Objection to DA59347/2020 – 2C Amethyst Avenue Pearl Beach

The Development Application notification plans and supporting documents have been reviewed. The proposed development is objected to for the reasons detailed below.

Illustration 1: Proposed height profile against 6 Pearl Parade. The proposed roof line will extend half way up the gable of 6 Pearl Parade.

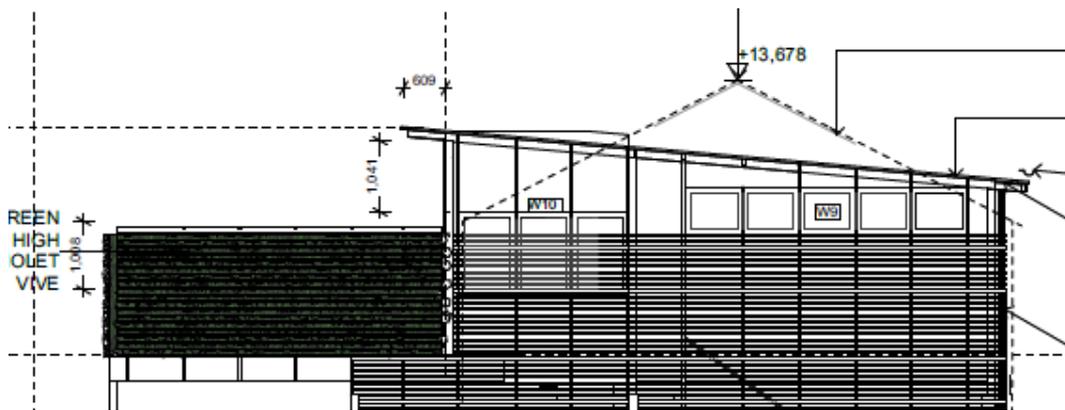
In summary, the proposed dwelling house constitutes overdevelopment of the small site, resulting in building massing to the detriment of [redacted] property. The efforts to achieve privacy screening worsen the building's bulk and scale. The affected areas of [redacted] property are the rear garden and the deck, living room and rear bedroom of the eastern elevation – refer to **photo 1** on the following page. The DA submission mistakenly assumes that by siting the development against the western elevation of 6 Pearl Parade this somehow facilitates the proposed building height and scale – refer **photo 2** on the following page. The proposed development, however, is beyond the capacity of the small site and would result in development which will dominate the rear part of [redacted] property and the rear areas of the adjoining properties – refer **illustration 1** on page 3.

The 1704mm separation between the two floors, nominated for kayak storage, substantially and unnecessarily increases the building height. A floor to floor separation of 200mm would be structurally sufficient.

The increased building height is evident on all four elevations. It will increase overshadowing of the rear elevation ground floor deck of 6 Pearl Parade.

The 1.8 metre high screen walls around the 42.9 square metre rear elevation first floor deck further add to bulk and height. Generally heights between 1.5 – 1.6 metres are sufficient to prevent overlooking, being at or slightly above average eye-height. The deck itself is unnecessarily large, extending to both sides of the building and given that ground level private open space is available between the western elevation and the boundary with [REDACTED] [REDACTED]. The 42.9 square metre area does not include the deck area to the east of the proposed new floor area.

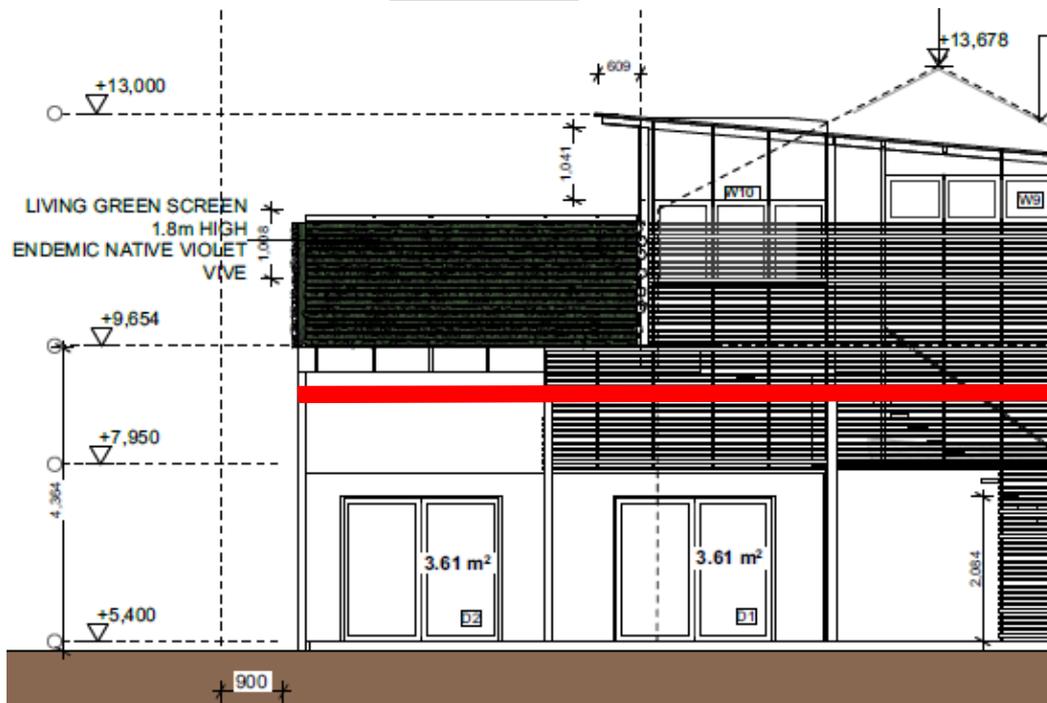
The existing rear setback (1.11 metres - drawing A-02) is retained as 1.106 metres on the un-numbered elevation drawing, with the result that when viewed from [REDACTED] property, the building height (towards the rear boundary) changes from 3.66 metres, (measured to the receding roof ridge – see **photo 3**) to 6.23 metres - see **Illustration 2**.

This increase in height needs to be understood in the context of:

- i. No improvement in regard to the rear setback (or overall building length);
- ii. The western elevation is 2 metres closer to the western side boundary, and
- iii. The western side elevation is unbroken rather than articulated.

The western elevation to [REDACTED] property is essentially an unbroken wall comprising different materials and finishes, with a total wall length of 13 metres. The western elevation comprises 85% of the site’s depth. The proposed development ignores rather than responds to the site’s small area and dimension limitations.
